**PLANNING COMMISSION
THURSDAY, APRIL 7, 2022 6:00 PM**

1. Application 2022-5014; 7332 E Main St; Main and Lancaster Development Major Site Plan; Applicant: Tim Spencer Trivium Development LLC

RE: East Main and Lancaster Ave – Major Site Plan #2022-5014 Staff Report

On behalf of the City of Reynoldsburg, EMH&T conducted a preliminary engineering review of the private development plan for the proposed project at 7332 East Main Street which is also known as the Happy Dragon site. The following summarizes our findings and recommendations with respect to this development.

CITY OF REYNOLDSBURG, OHIO
 MAJOR SITE PLAN
 FOR
 TRIVIUUM - REYNOLDSBURG

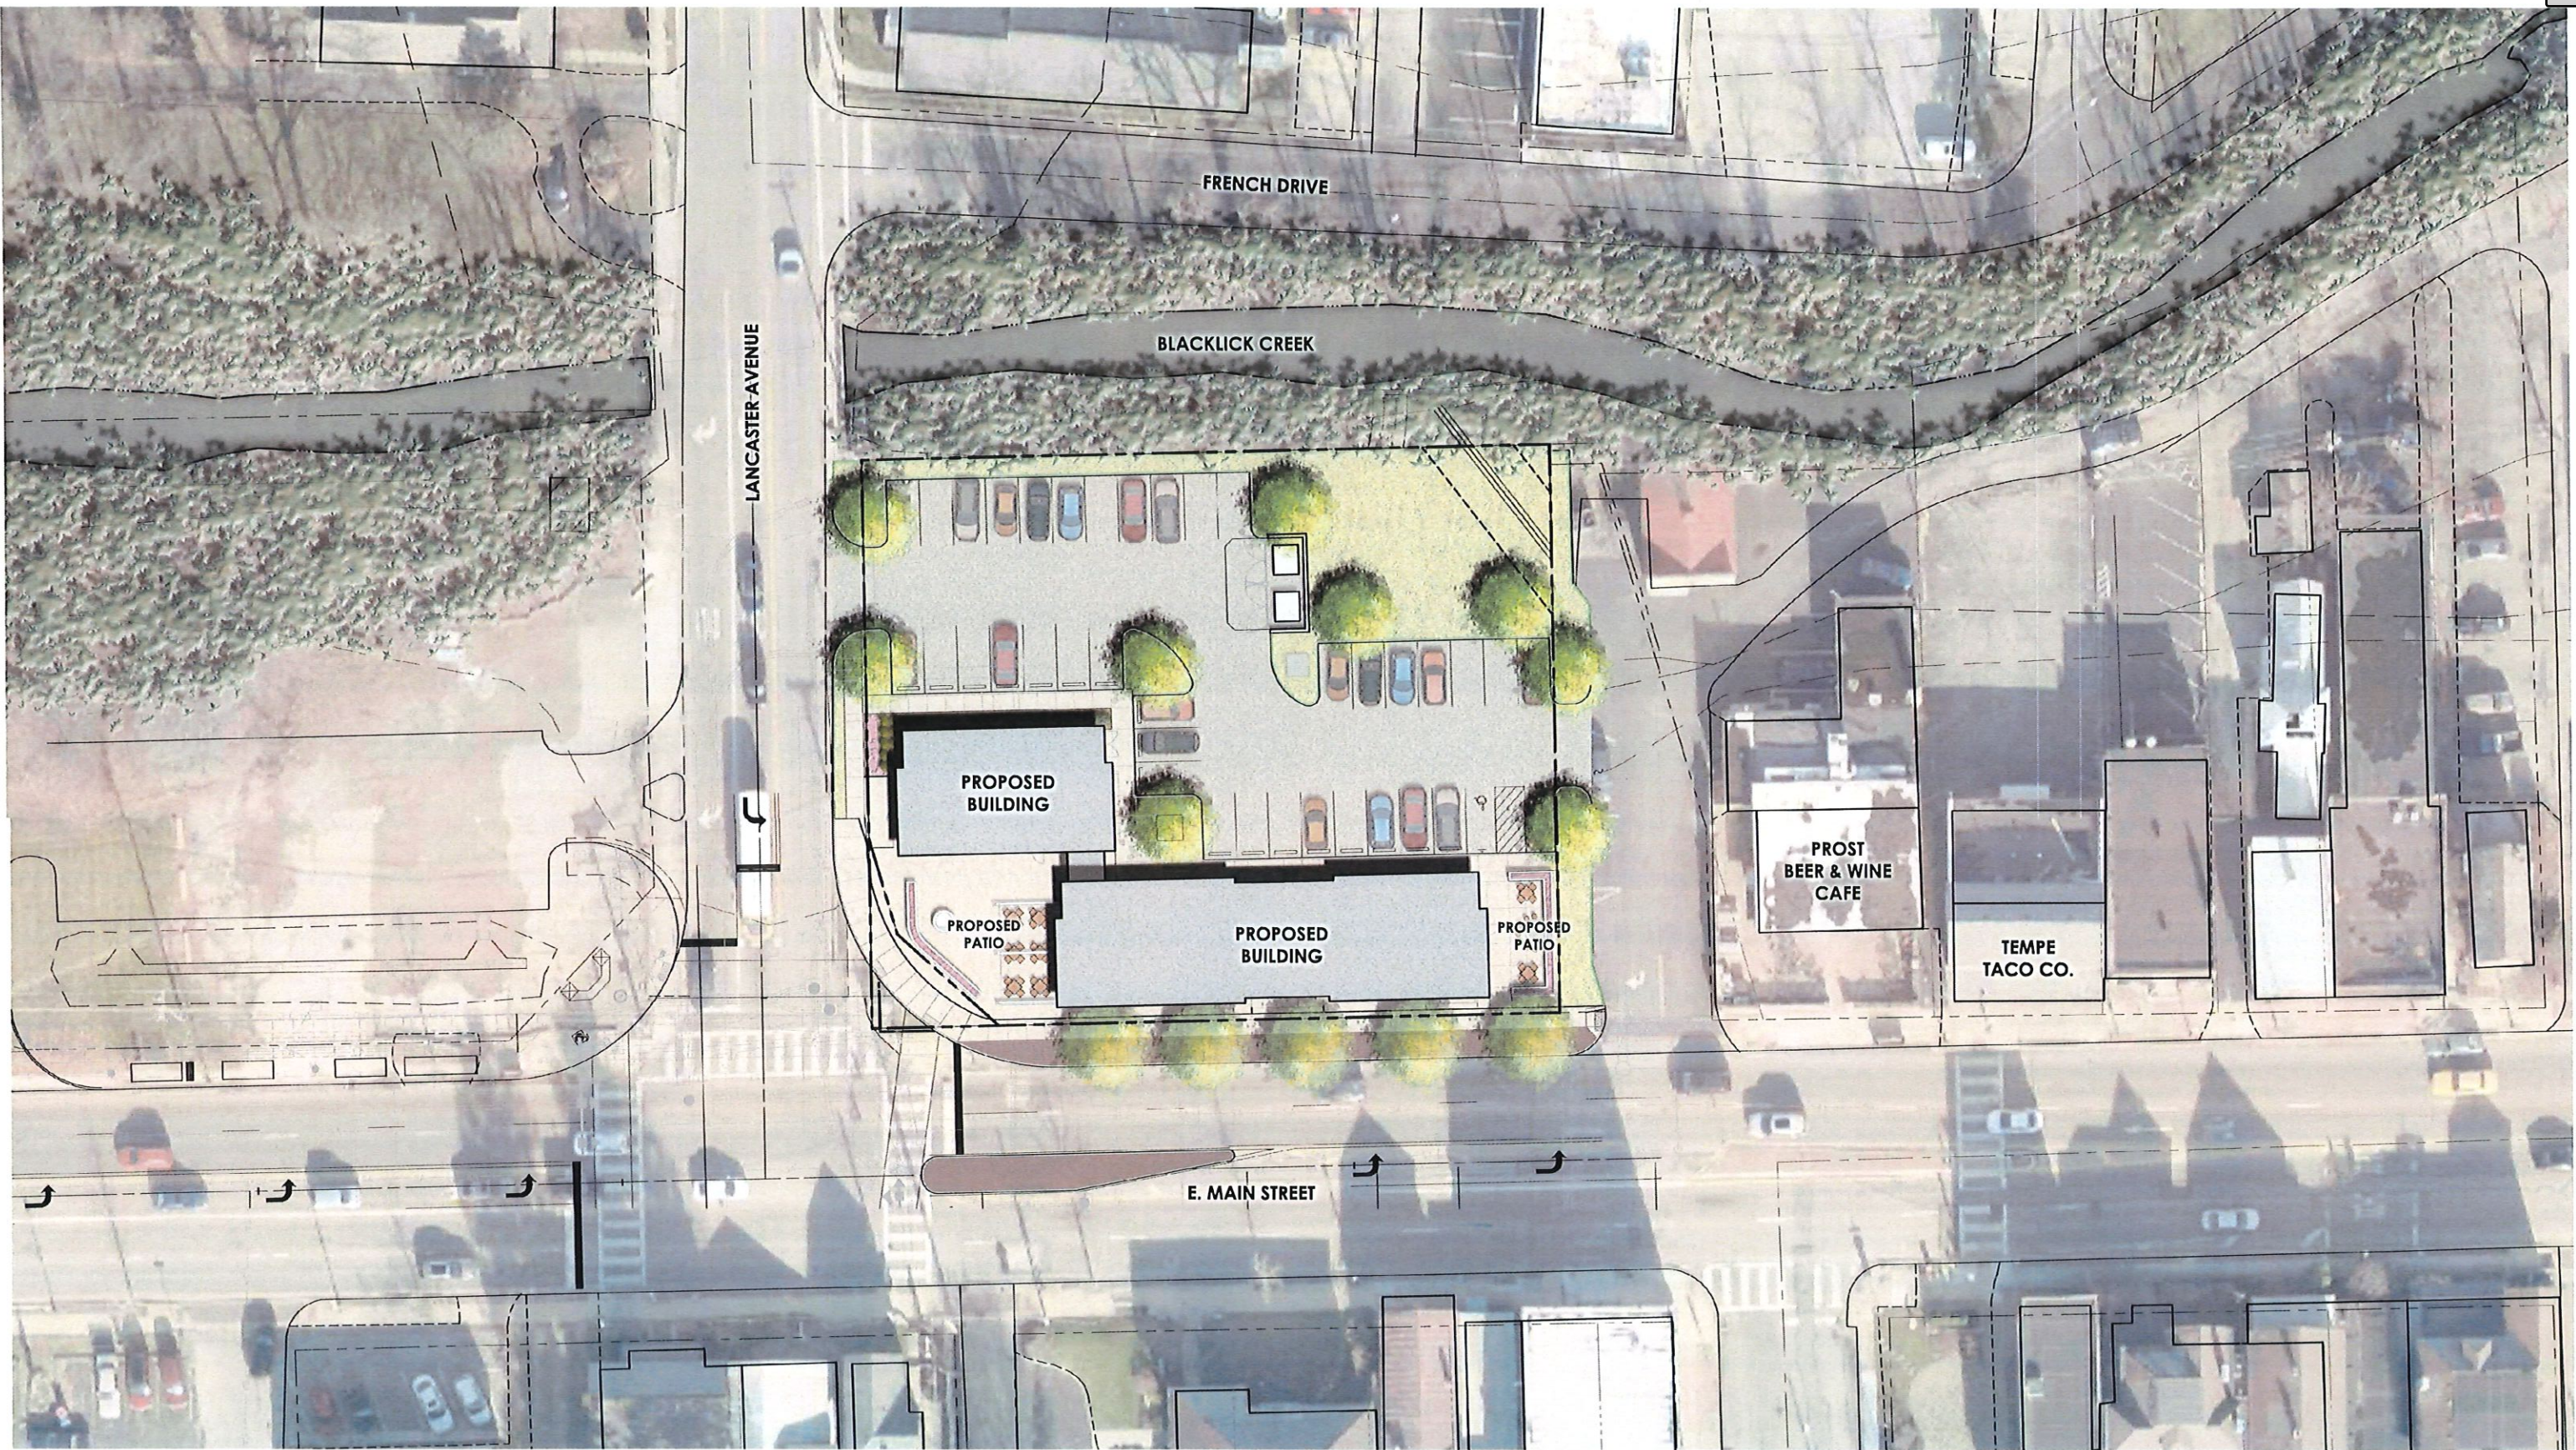
4. The site is proposing 22' wide drive aisles onsite and directly to the east of the parcel. This will be sufficient for normal vehicular traffic.
5. The development provides adequate onsite parking (38 spaces) based on the parking calculation and the proposed uses shown. It is noted that the development also proposes to install/improve parking in the rear of adjacent businesses to the east to provide a total of 42 "shared" offsite spaces. However, it appears only 36 spaces are shown.

6. The project will need to provide ADA compliant ramps including detectable warnings at the western entrance.
7. It is not clear if curb is proposed for the rear of the onsite lot and/or for the offsite shared spaces. Please clarify in future submissions.

11. The site is proposing a 6” sewer service to connect to the existing 8” sanitary sewer located in East Main Street. The PGU plan will need to show details of the service (length, size, slope, etc.). The installation of the service is being coordinated with the City’s street project in an effort that the road improvements need not to be disturbed after completion.

12. The utility plan shows separate domestic and fire protection waterlines entering the building near the northwest corner. These lines will be fed from the existing 16” watermain located on the east side of Lancaster Avenue. Sizes of the lines and further detail will need to be provided on the PGU plan.

14. No storm sewer is currently shown on the site plan. Information is needed to understand how stormwater management will be handled for this site. A stormwater management report and calculations will need to be submitted with the PGU plan. Grading information will also be required.

15. It is noted that the existing bioretention basin is to remain. However, no information has been included on how this will continue to be fed with runoff, or if it will need to be expanded, etc. Please provide this information in future submissions.

16. Please coordinate with the City’s East Main Street design team regarding the existing catch basin being shown to be removed. The City’s street improvement plan is intending to install infrastructure to accept this catch basin. Also, please consider if the patio area located in the southwest corner of the project will require any storm sewer, area drains or similar. The City’s storm sewer intended for the catch basin previously noted may be able to accept this area.
